### **ADDENDUM #3**

#### **Rye City School District**

***Issued: 2021-02-11***

**This Addendum No. 3 forms part of the Contract Documents and modifies the original bidding documents dated, January 19, 2021.**

SEAL & SIGNATURE	DATE:	11/07/19
	PROJECT No:	9200
	DRAWING BY:	BGA
	CHK BY:	BGA
	DWG No:	E2-304

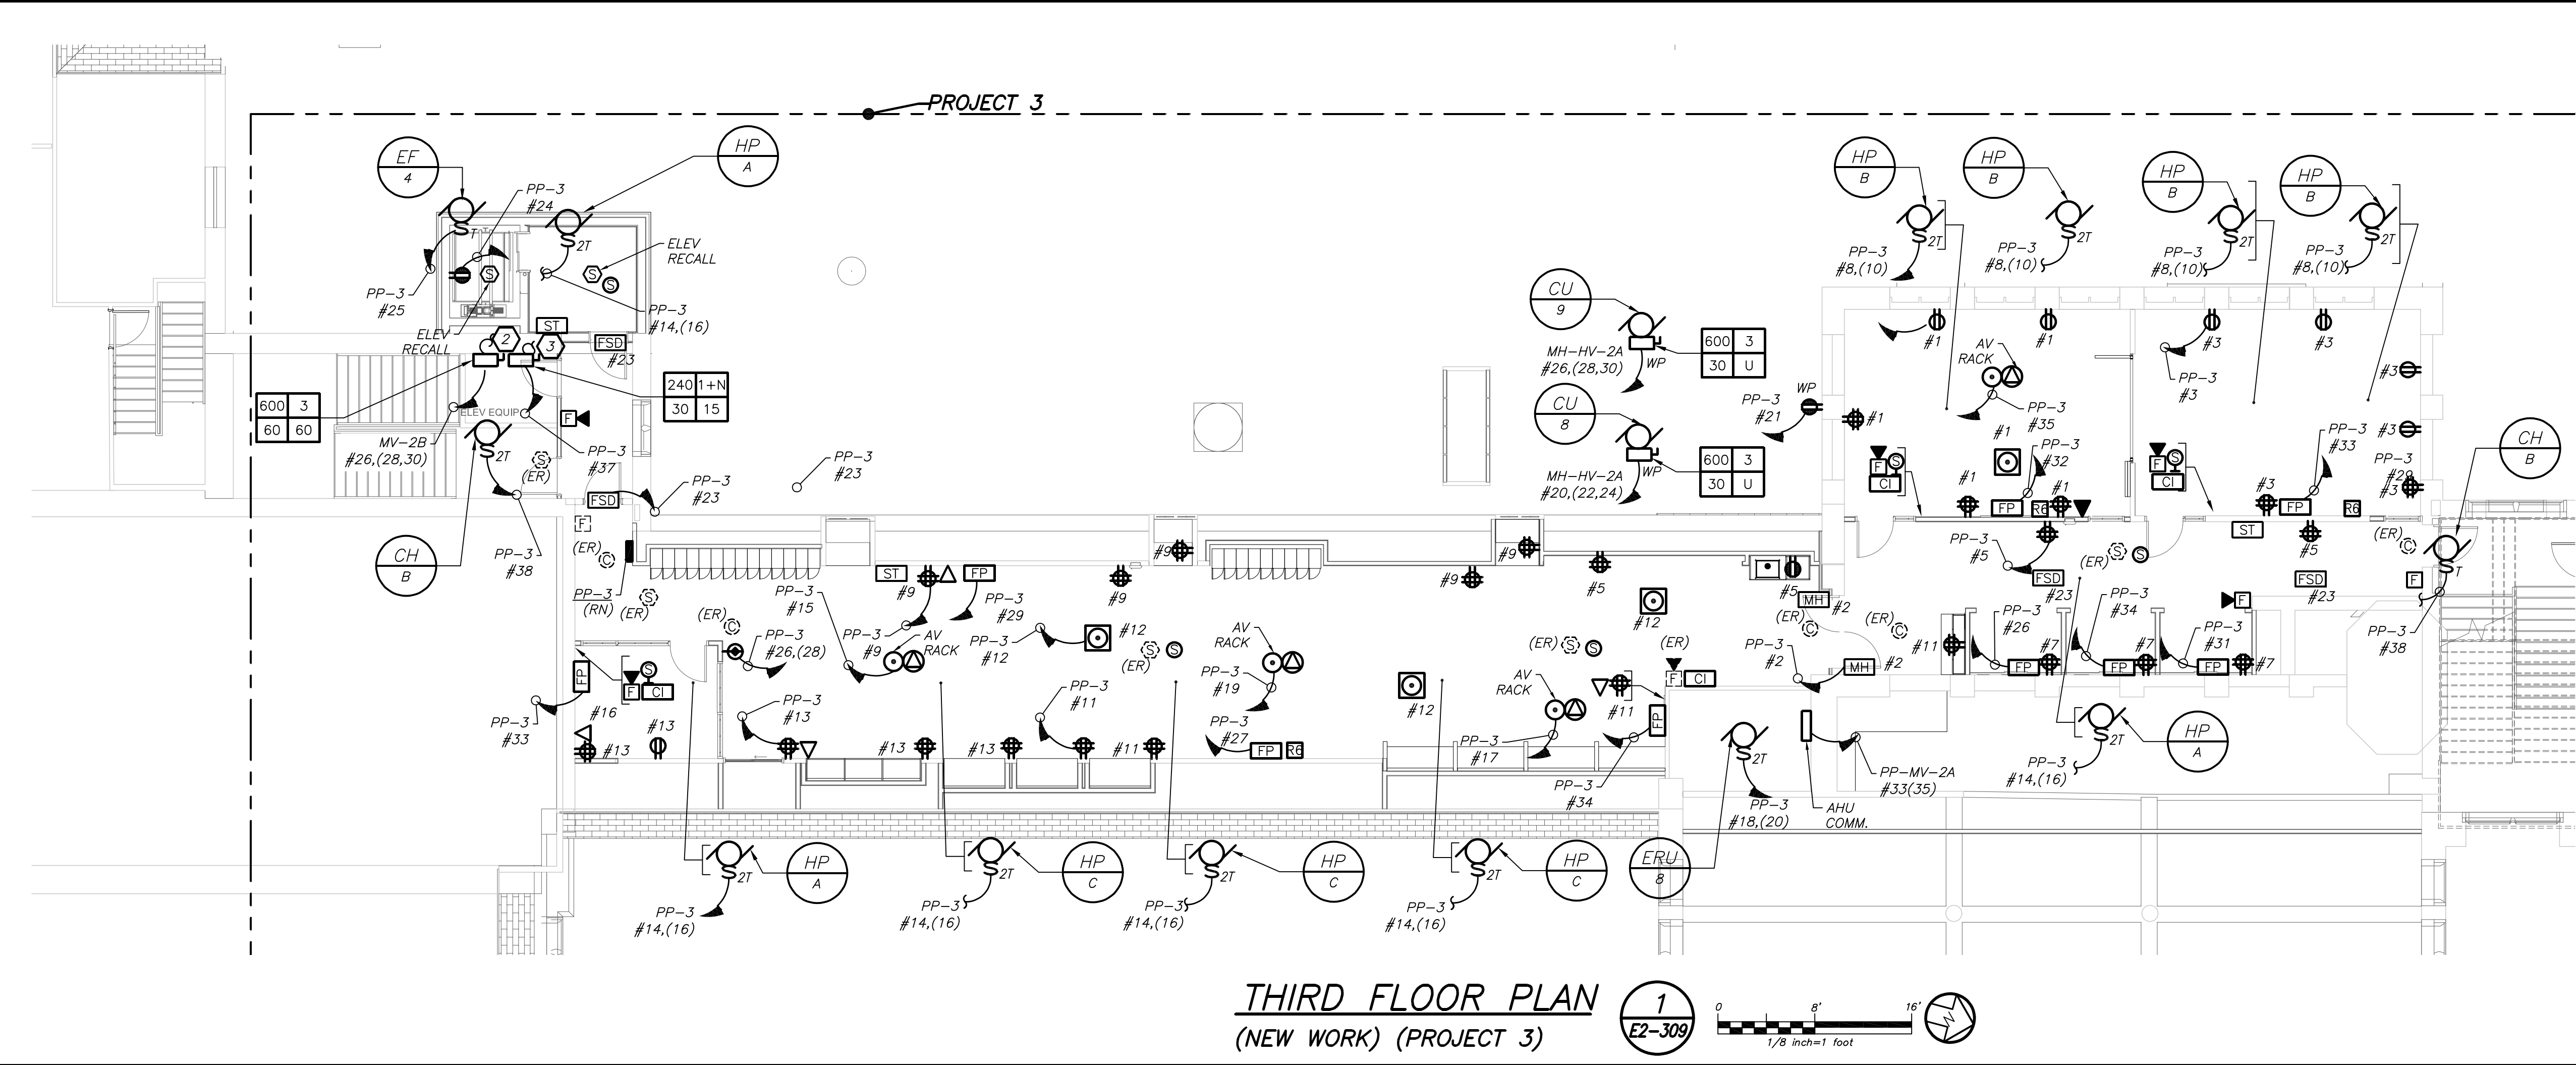
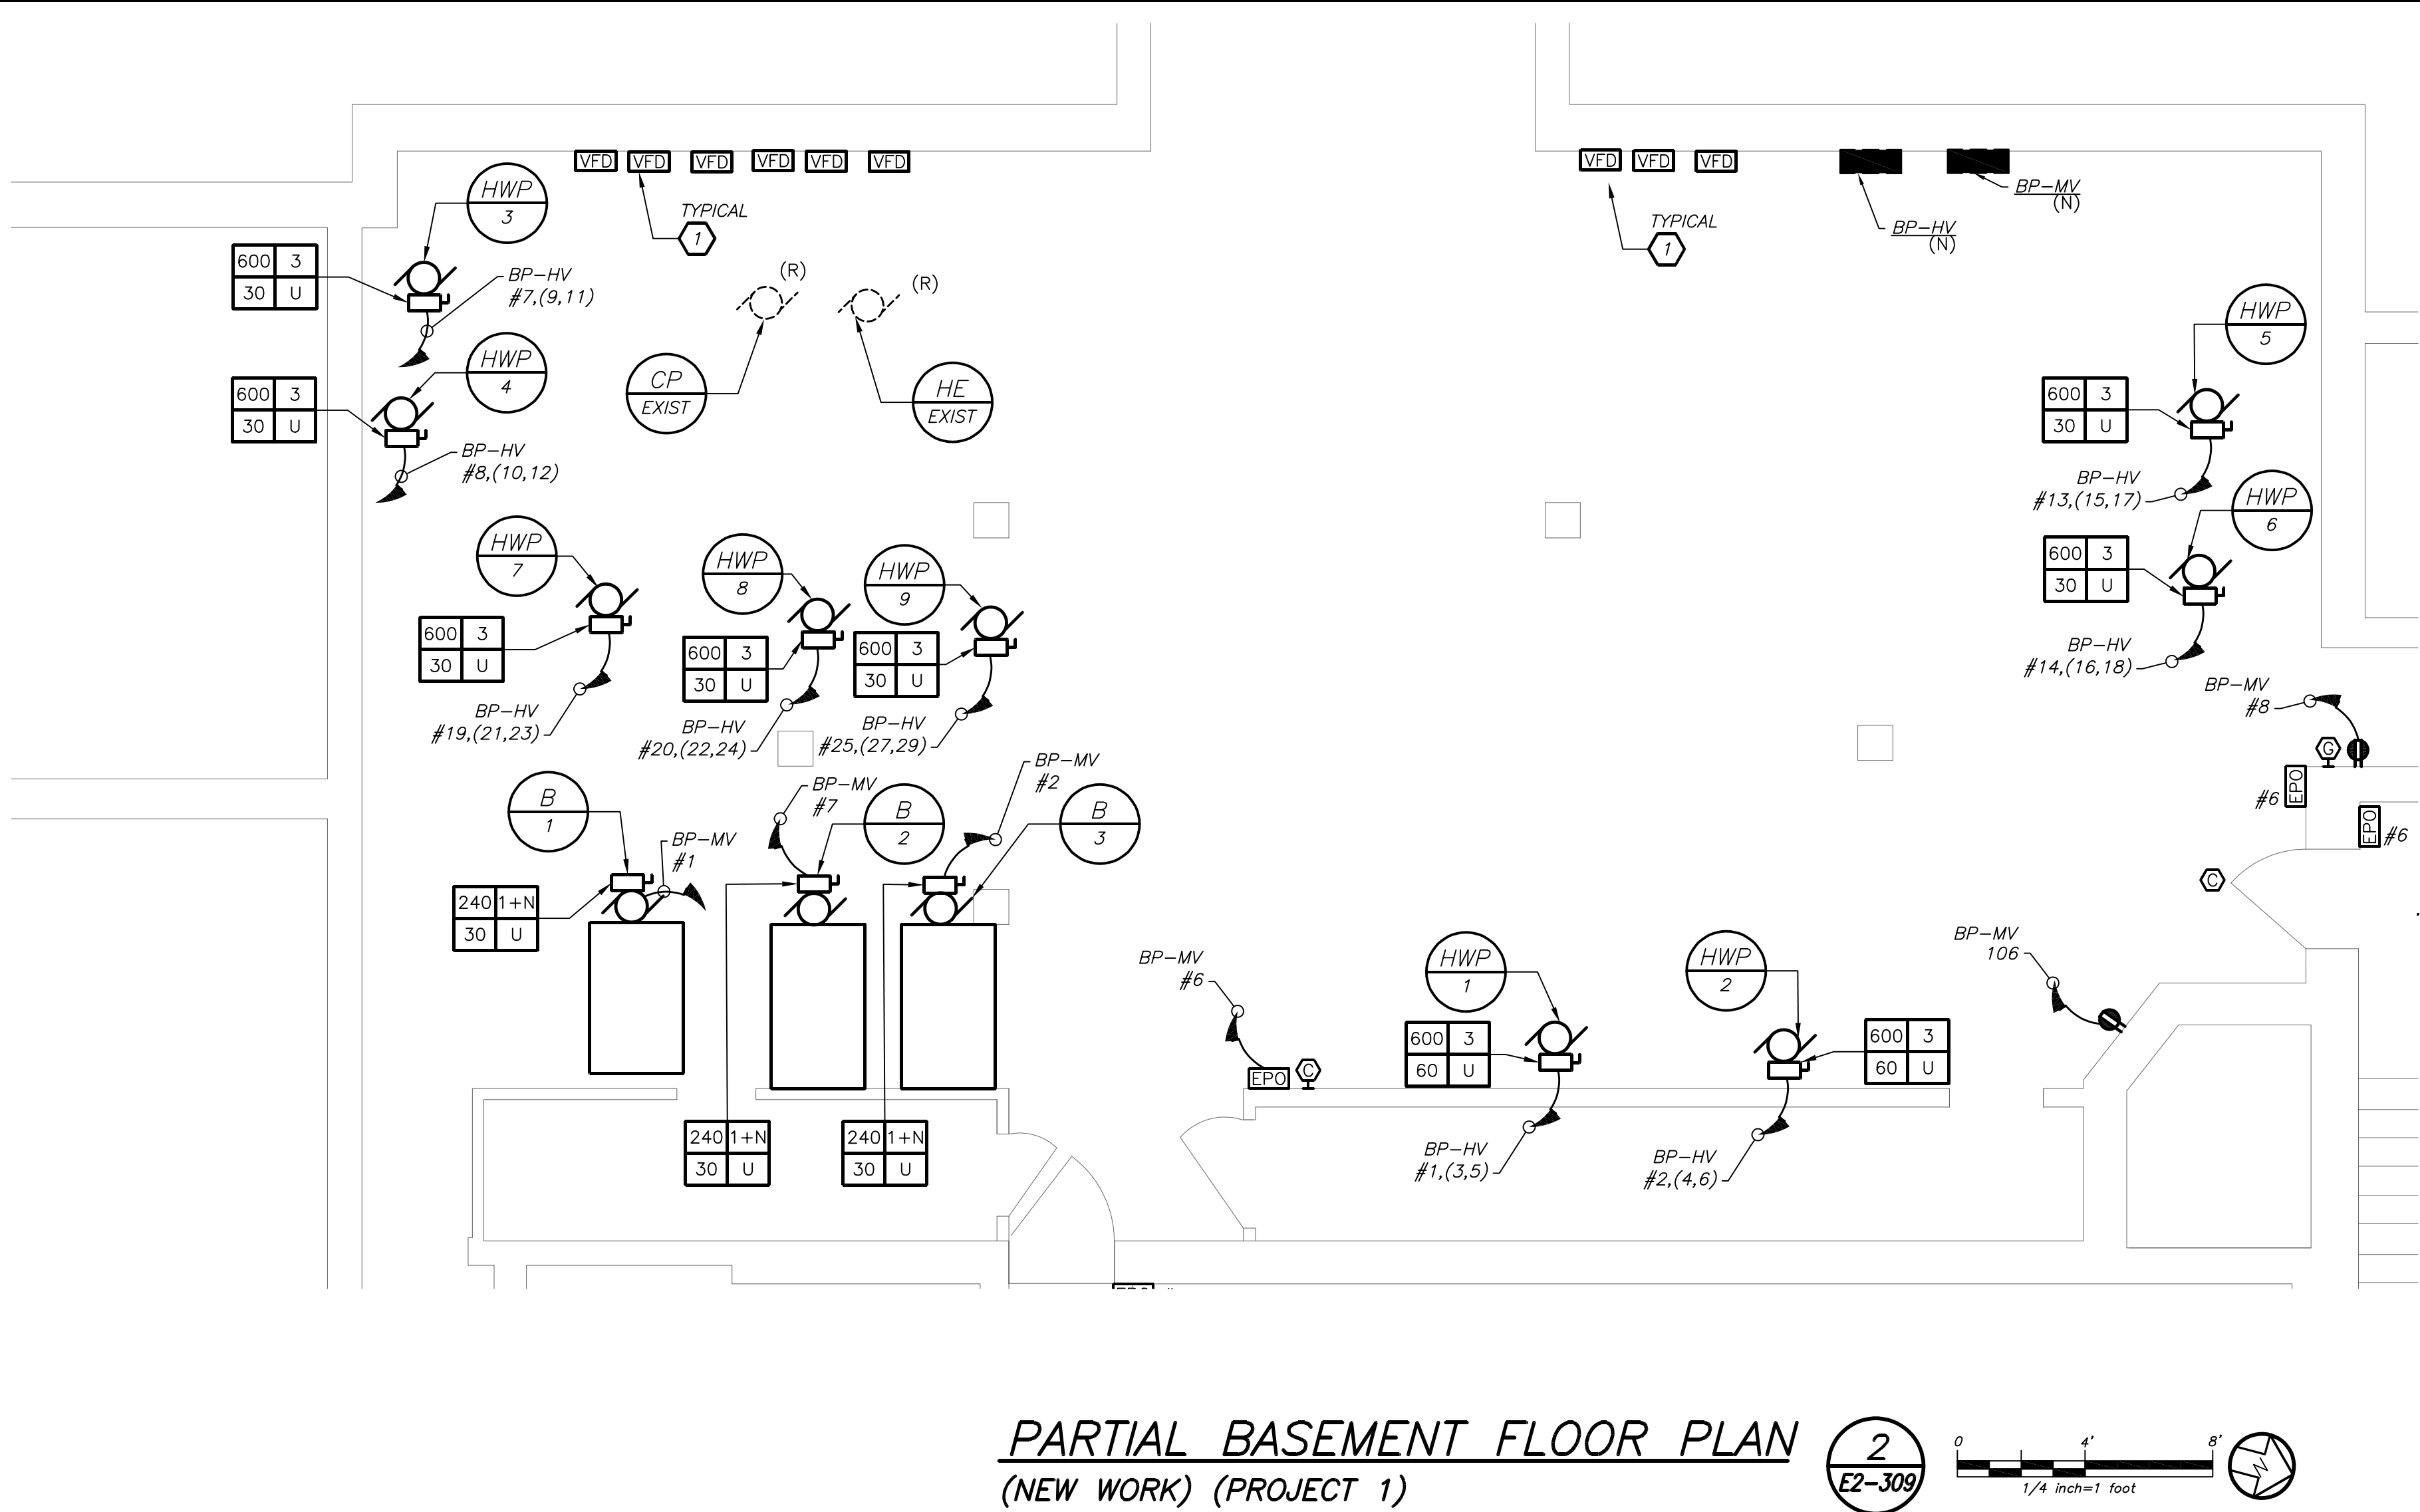
- a. All work related to the Telecoil Loop shall be “Project 2A.”
- b. Provide data drop for Telecoil Loop Headend.
